ER/WM-060/04
August 23, 2004

SUBJECT: Contract No. DE-AC24-03OH20152
Statement of Work Requirement 055 - Regulator Reports
**Building R, SW, 58, and 68 Slab Removal Action, Action Memorandum,
Addendum 1, August 2004**

ACTION MEMORANDUM

ADDENDUM 1

Figure 2.1
Location of Buildings R, SW, 58, and formerly 68

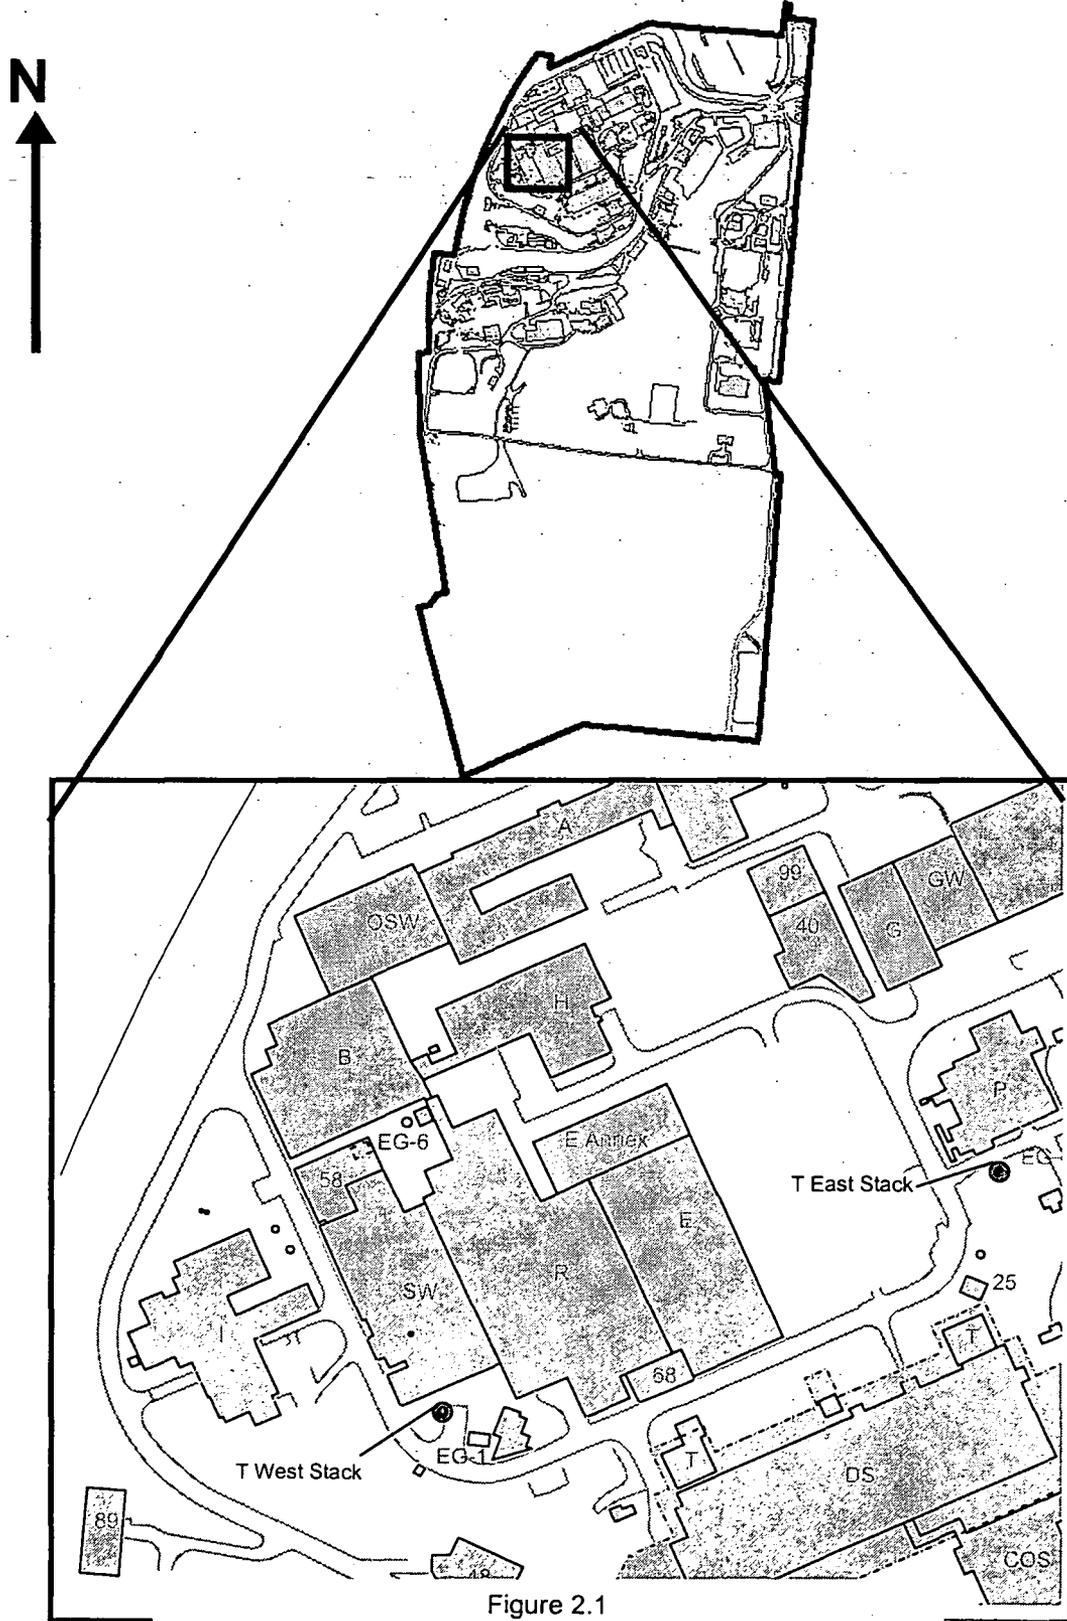
The Miamisburg Closure Project is a site on the southern border of the city of Miamisburg in Montgomery County, Ohio. The additional removal action is proposed for T East and T West stacks shown in Figure 2-1.
